MISTER CAR WASH

SITE CONSTRUCTION PLANS

SITE PLAN SUBMITTAL

STORM LINE 1 PLAN
SCALE: 1"=20'

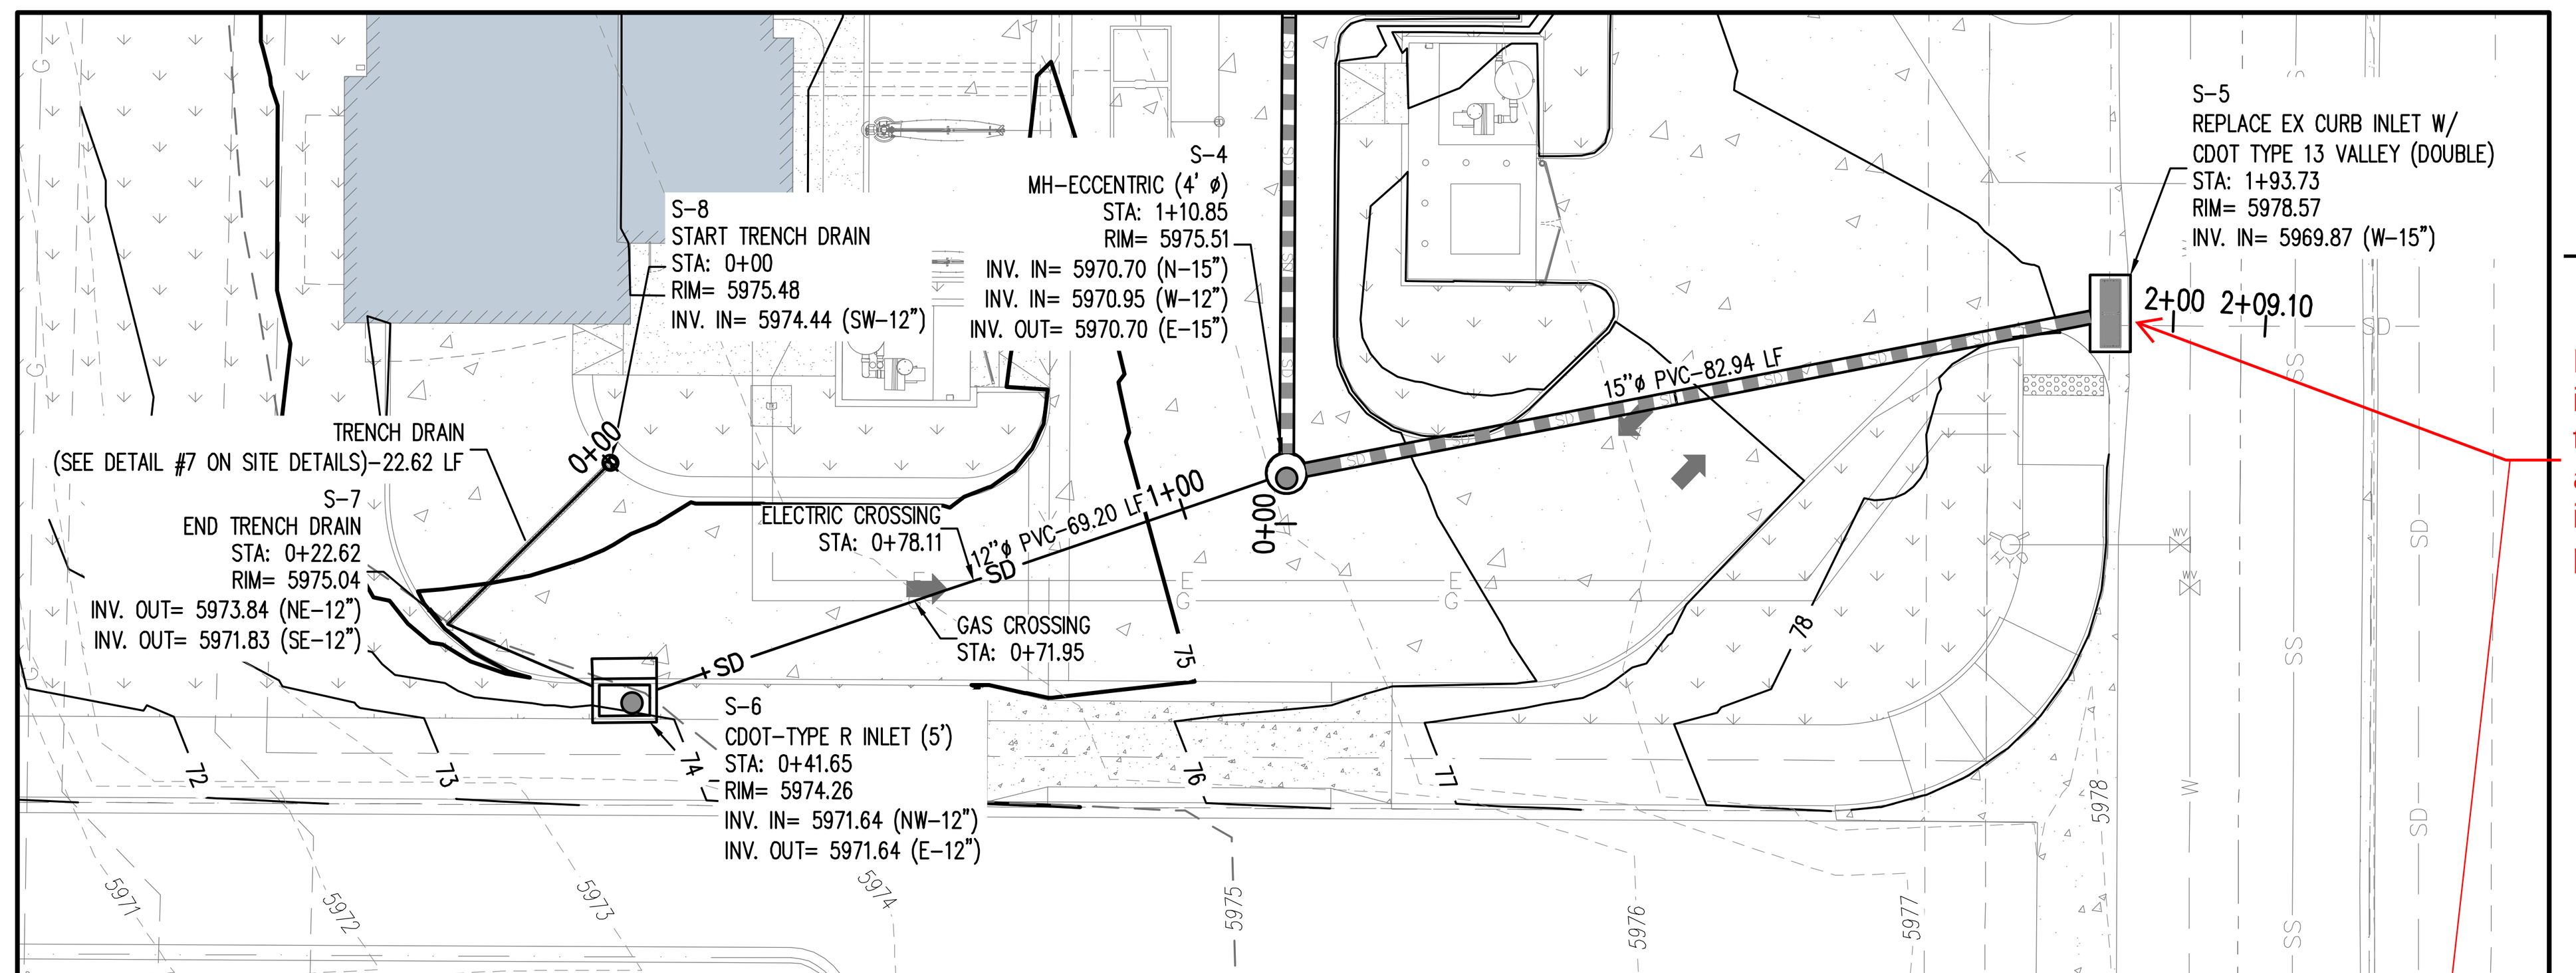
On all storm plans, please include all proposed and existing easements and provide reference reception no. or book and page for existing easements.

Provide the invert out information for tie-in to existing storm drain and show this information on the profile as well.

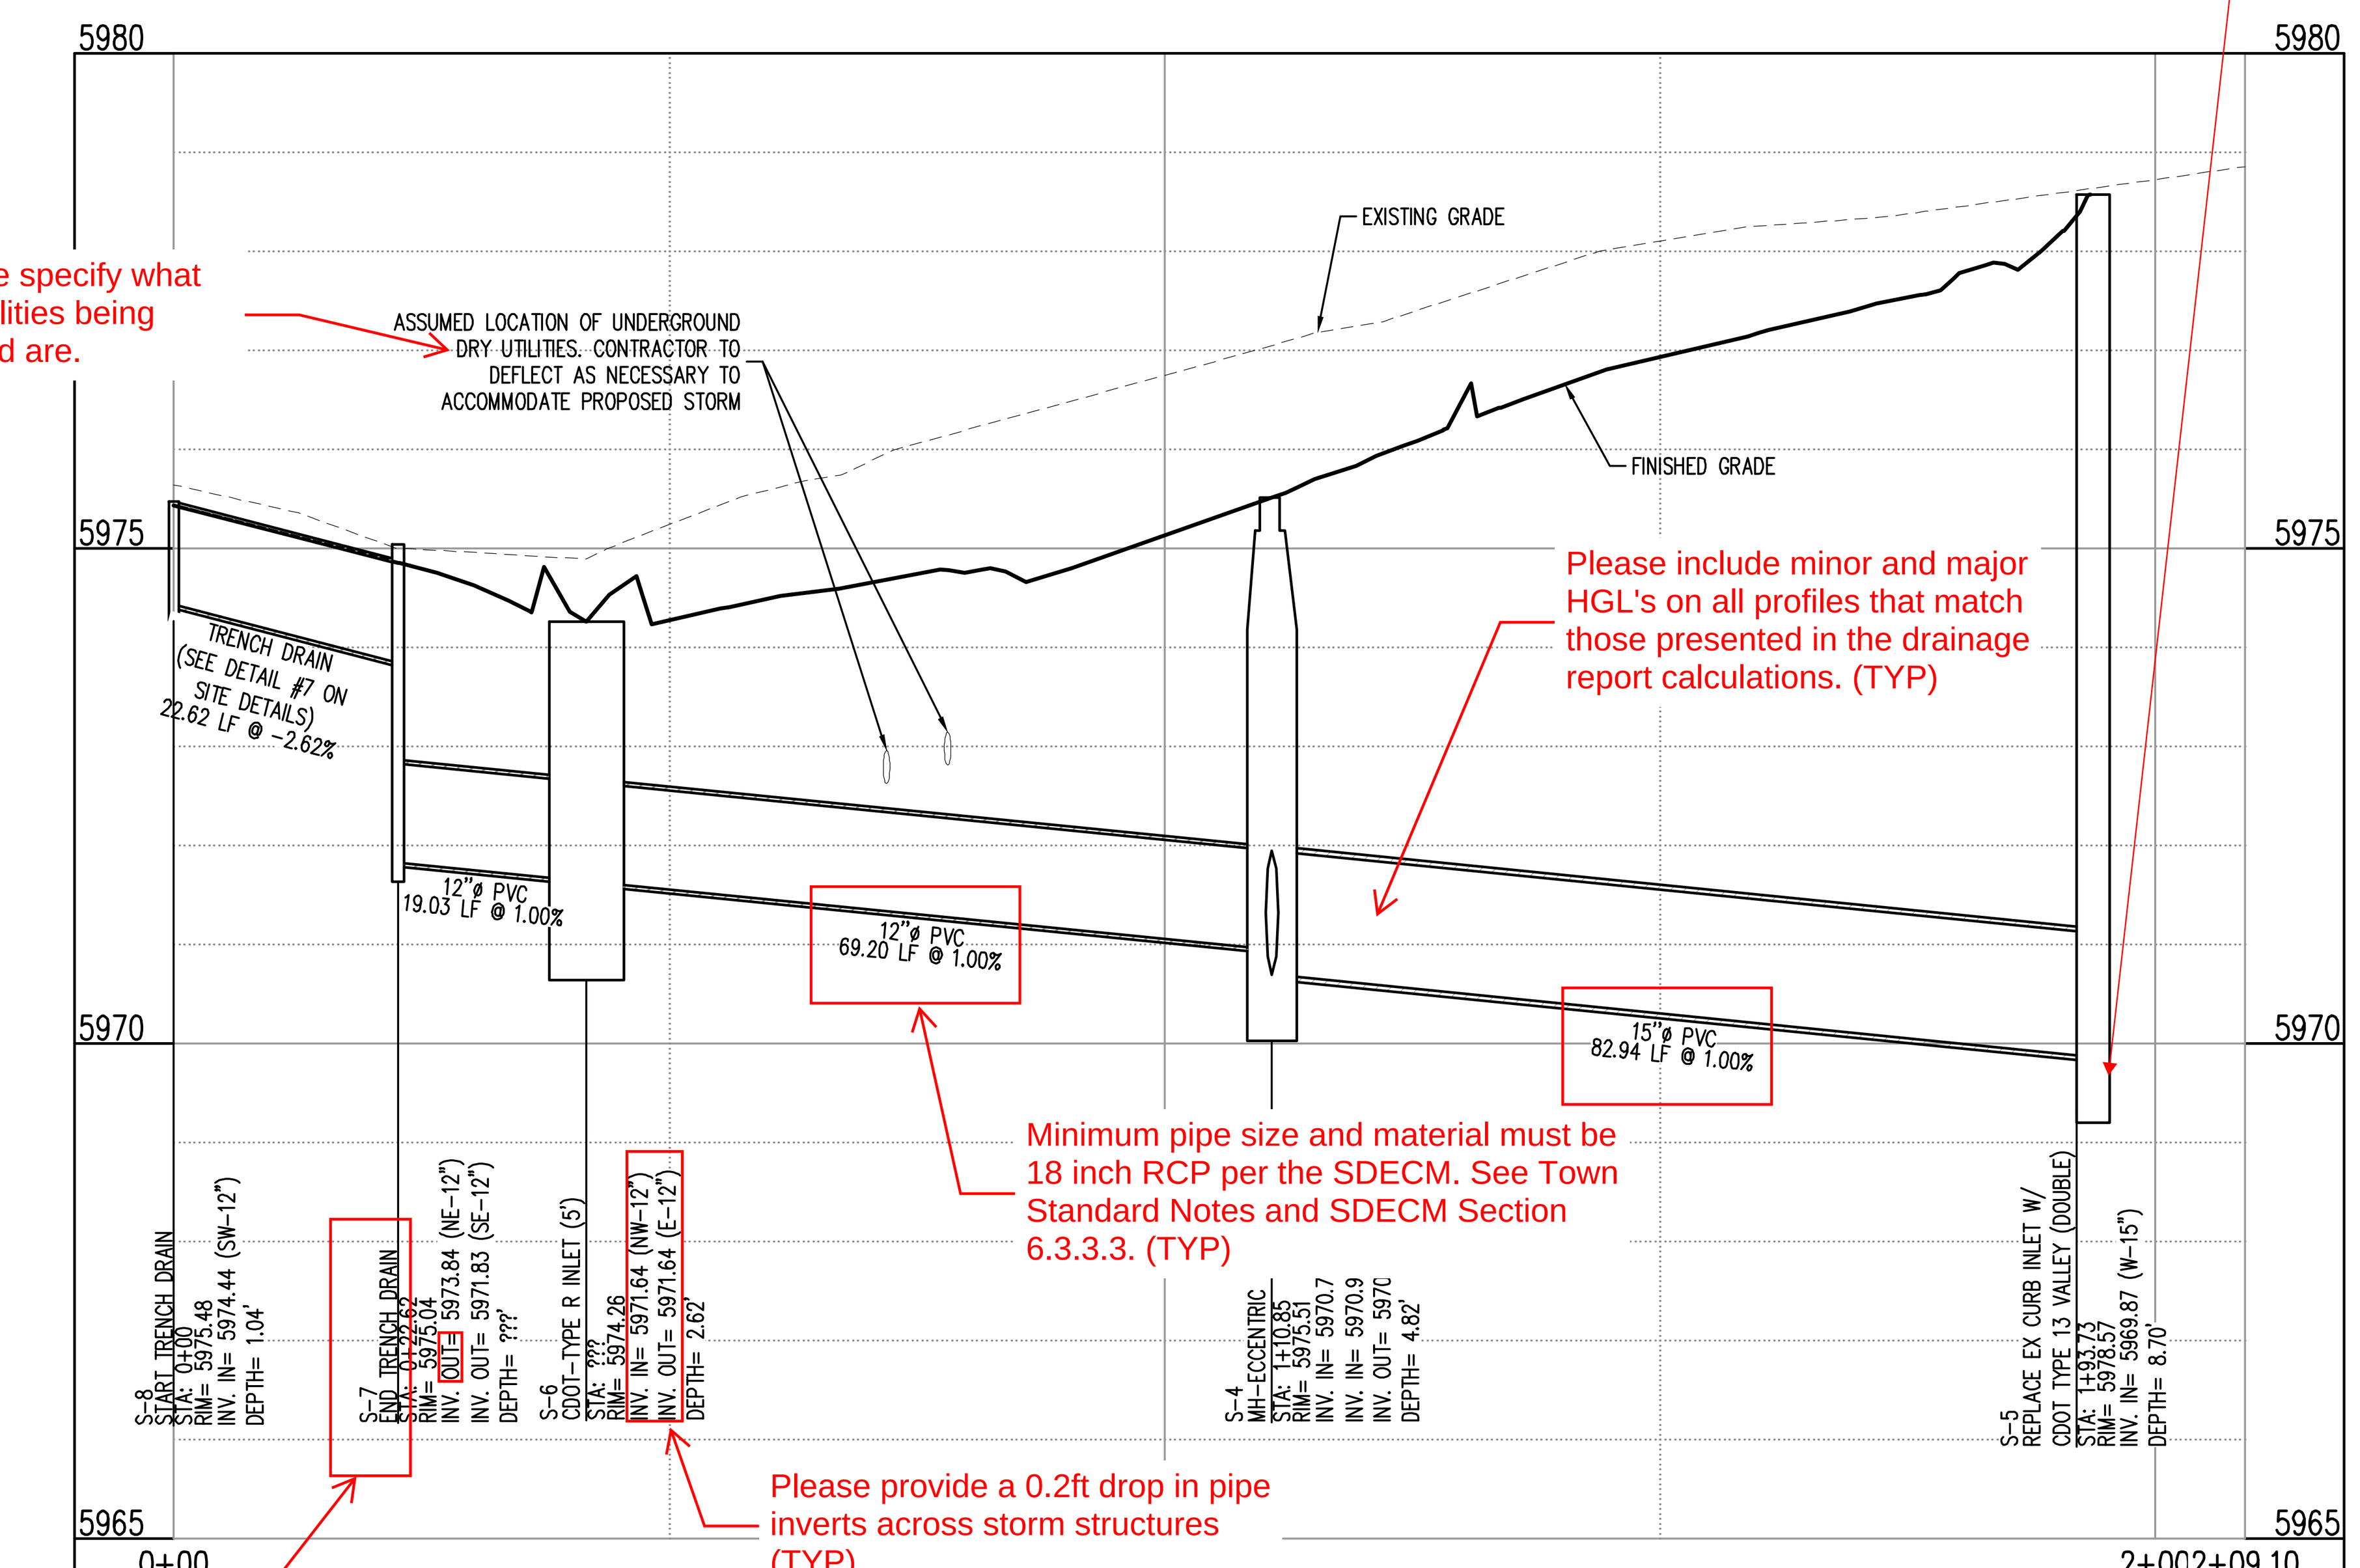
Please specify what dry utilities being located are.

Please include a label of the structure type and a detail.

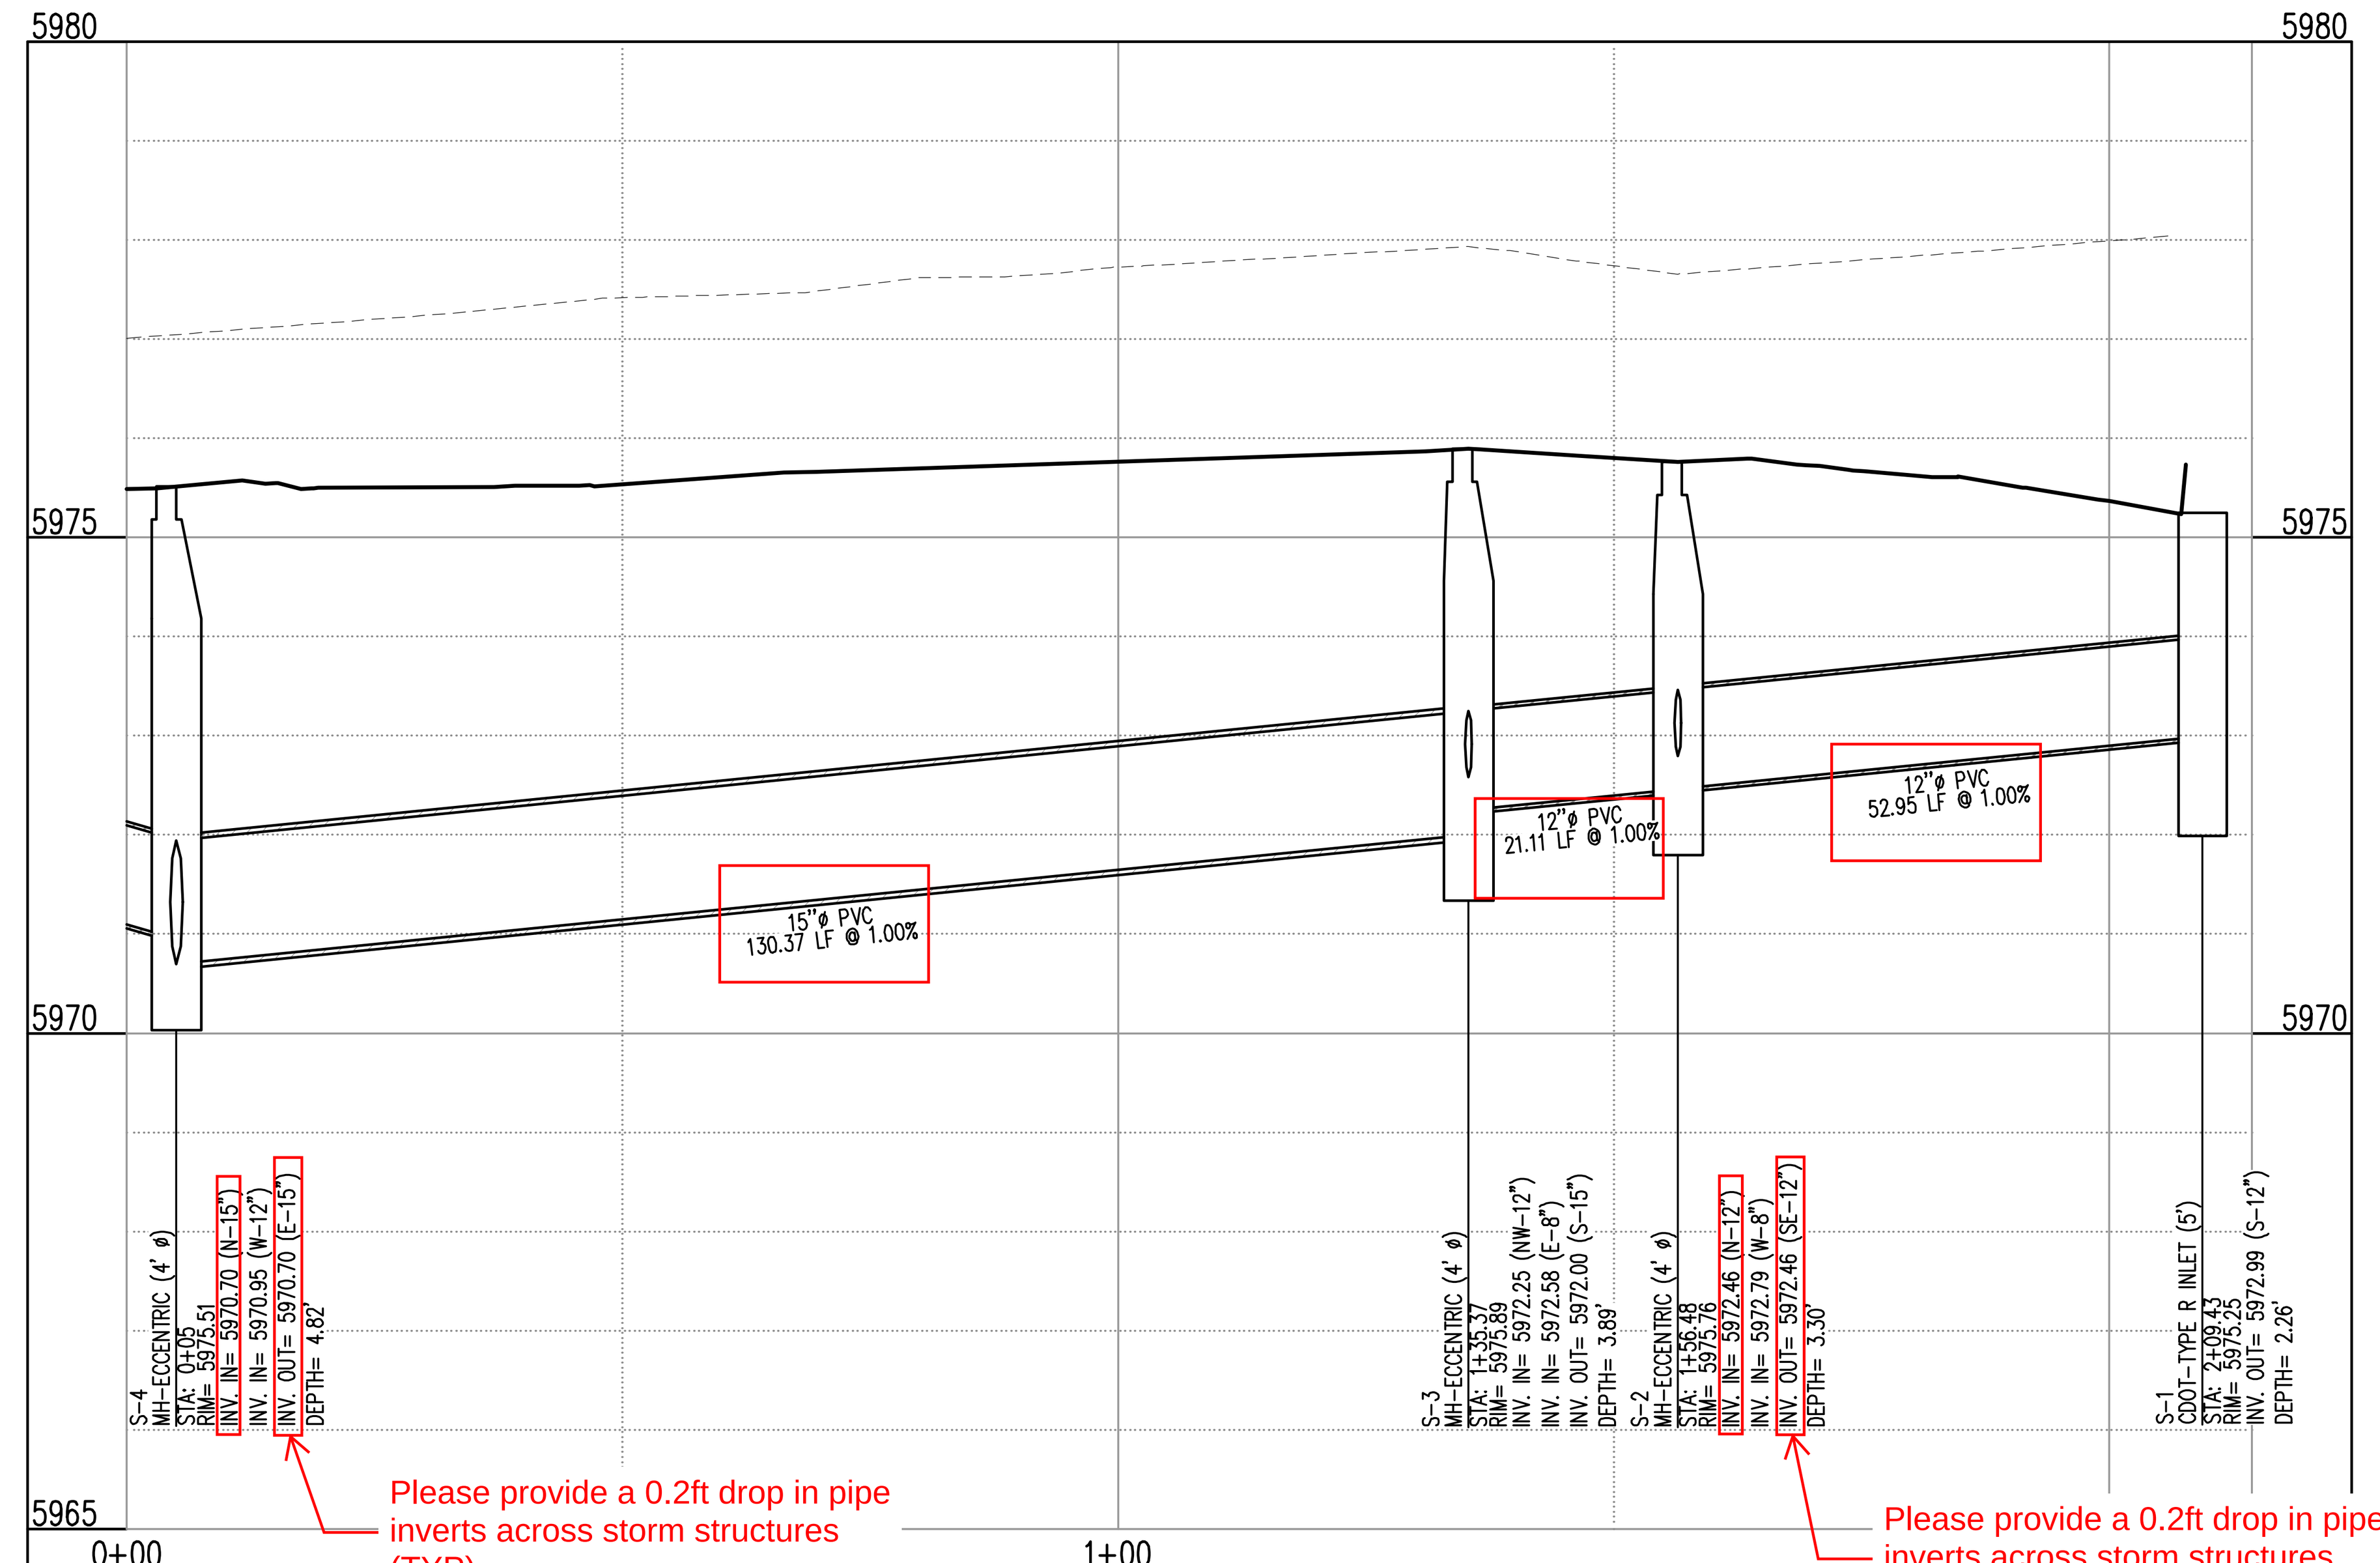
Please provide a 0.2ft drop in pipe inverts across storm structures (TYP)
